TRANSGRID REVISED REVENUE PROPOSAL APPENDICES

An independent review

APPENDIX B
WALLEROO-WILLIAMSDALE 330 KV TRANSMISSION LINE AND SUBSTATION

Option A – Bungendore-Williamsdale 330 kV Line

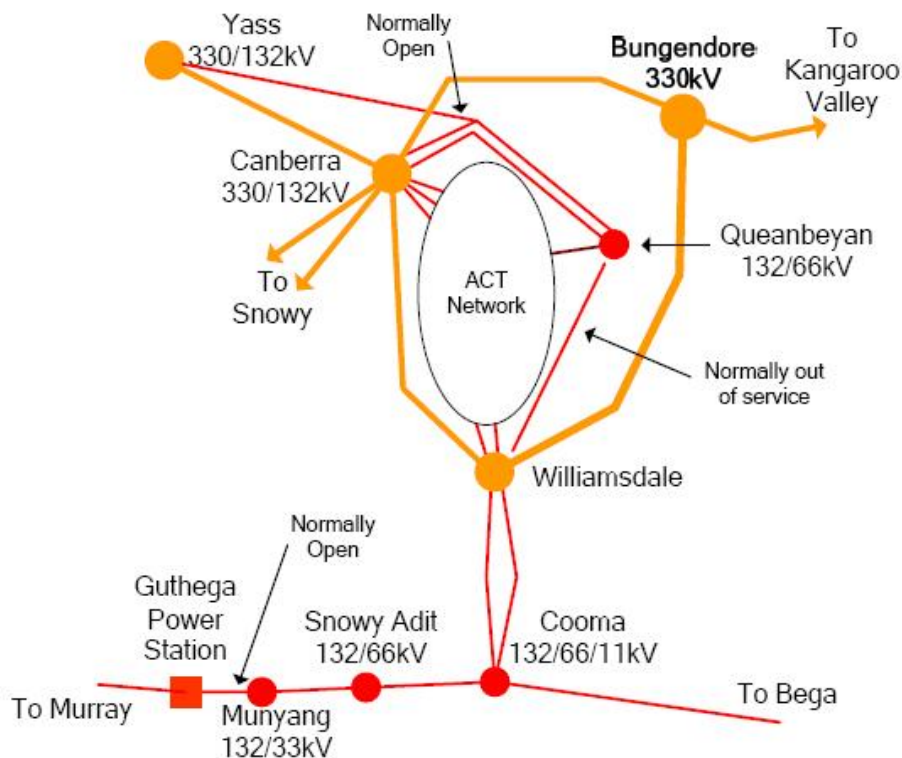
Option A involves bypassing the Canberra Substation and the Canberra-Williamsdale 330 kV lines with a geographically separate 330 kV transmission line. Option B, D and E involve the use of the existing Yass-Canberra-Williamsdale 330 kV line routes.

Option B – Wallaroo Switching Station

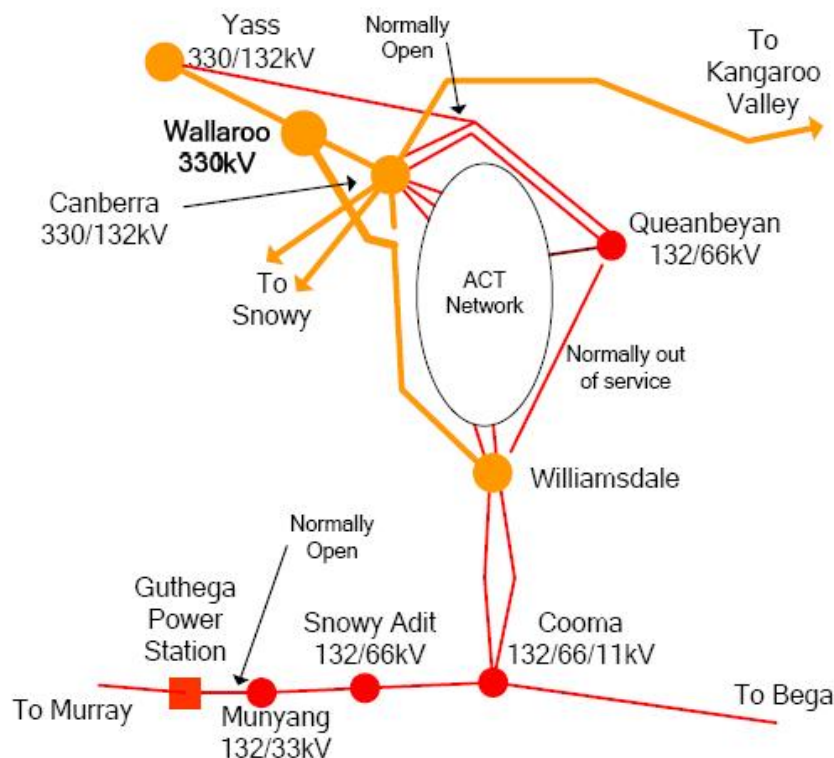
PB notes that the significantly lower estimated cost and higher NPV of Option B is consistent with the significant utilisation of existing infrastructure under this option. The primary purpose of Options B, D and E is to consider whether it is more efficient to construct a new switching station between Yass and Canberra or to duplicate or rebuild the existing 330 kV line.

On the basis of the costs presented by TransGrid, the length of the Yass-Canberra 330 kV line is such that the provision of the Wallaroo switching station and comparatively short line works to bypass the Canberra substation represents more efficient investment than the remaining options, which require far more extensive line construction.

Given the significant reduction in the capital cost required to satisfy the stated project need under Option B, PB considers that, of the options presented by TransGrid, Option B represents the most efficient scope and cost for meeting the stated need.

Therefore PB recommends that \$0.85m be removed from TransGrid's revised ex-ante capex proposal on the basis that it represents a risk allowance inconsistent with TransGrid's Capital Accumulation process.

Option D – Yass-Williamsdale Single Circuit 330 kV Line

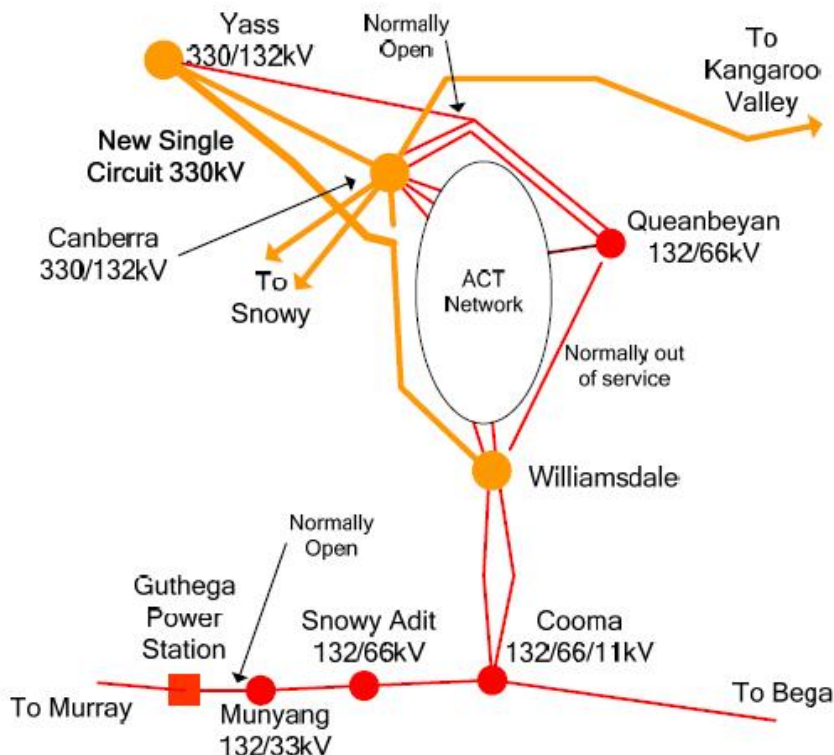
Option B requires the establishment of a new switching station at Wallaroo with a short section of single circuit 330 kV Transmission Line constructed to bypass the existing Canberra Substation. In contrast, Options D and E avoids the need for the Wallaroo switching station by either the duplication of the Yass-Canberra single circuit 330 kV line or its reconstruction as dual circuit to provide a supply independent of the Canberra Substation.
